On behalf of the Department of Energy (DOE) and Sandia Corporation (Sandia), DOE is responding to the October 30, 2007 Notice of Approval: Monitoring Well Plug and Abandonment Plan and Replacement Well Construction Plan; Decommissioning of Groundwater Wells MWL-MW1 and MWL-MW3; MWL-MW7 and MWL-MW8, July 2007, Sandia National Laboratories, EPA ID No. NM5890110518, HWB-SNL-07-016. As detailed below, we have a number of concerns regarding the conditions of approval that define the locations of groundwater monitoring wells at the Mixed Waste Landfill (MWL).

Document title: Response to Notice of Approval: Monitoring Well Plug and Abandonment Plan and Replacement Well Construction Plan; Decommissioning of Groundwater Monitoring Wells MWL-MW1 and MWL-MW3; Installation of Replacement Groundwater Monitoring Wells MWL-MW7 and MWL-MW8, July 2007 (HWB-SNL07-016) November 2007

Figure 1
Location of Existing and Proposed Groundwater Monitoring Wells at the Mixed Waste Landfill

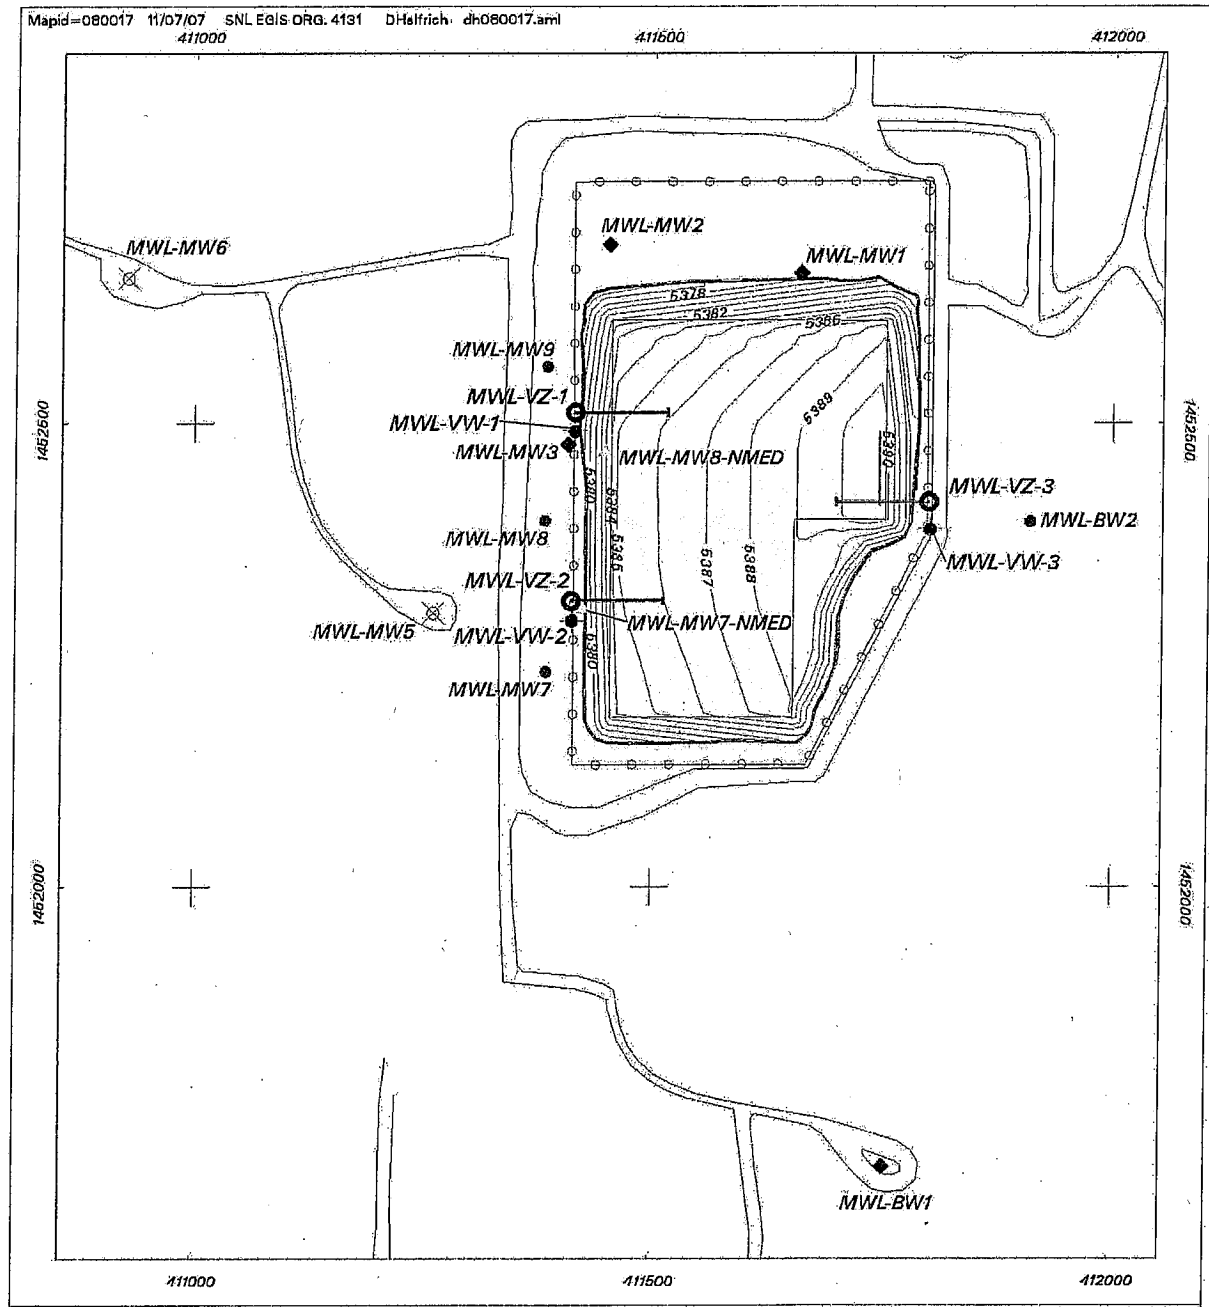
- *The proposed location of monitor well MWL-MW7 must be moved 80 feet at a bearing of 30° northeast from where it is shown on Figure 1 in the work plan.*
- *The proposed location of monitor well MWL-MW8 must be moved 100 feet at a bearing of 40° northeast.*
- *Both new wells shall be positioned as close as possible to the former west fence that originally surrounded the Mixed Waste Landfill.*

- **Structural Integrity and Performance of the Engineered Cover--**The NMED locations pose a threat to the integrity of the engineered cover. Placement of wells through the cover could result in preferential pathways for liquids over the long term. As noted on

Figure 1 from the work plan (see enclosure for revised Figure 1) the engineered topography of the cover slopes to the west. In order to protect the wellhead, the slope of the cover would need to be redesigned which would involve a significant effort and significant delays in implementing the remedy. While design changes could alleviate some concerns, such as protecting the wellhead, the potential for creating conduits over the long term remains a critical issue.

- **Conflicts with the Monitoring Network Proposed in the LTMMP**--In the LTMMP (currently in NMED and public review) the DOE and Sandia proposed three wells on the western side of the landfill (outside of the security fence) to replace current monitoring wells, MWL-MW-1, -2, and -3. These three wells (MWL-MW-7, -8, and -9) are shown on Figure 3.5.1-1 in the LTMMP. The wells proposed in the LTMMP are evenly spaced along the western side of the landfill and represent downgradient points of compliance. The proposed NMED locations would significantly change this configuration. In addition, the NMED locations interfere with the neutron access tubes (already in place) and the locations for the soil-vapor sampling wells as proposed in the LTMMP. The two proposed soil-vapor wells located on the west side of the landfill are evenly spaced along the edge of the cover (Figure 3.4.1-1 in the LTMMP). Please refer to Figure 1 (enclosed), which includes all monitoring and soil-vapor well locations proposed in the LTMMP and the proposed NMED locations. DOE- and Sandia are currently preparing a plugging and abandonment plan for MWL-MW2 that includes the installation of MWL-MW9 at the location shown on Figure 1.
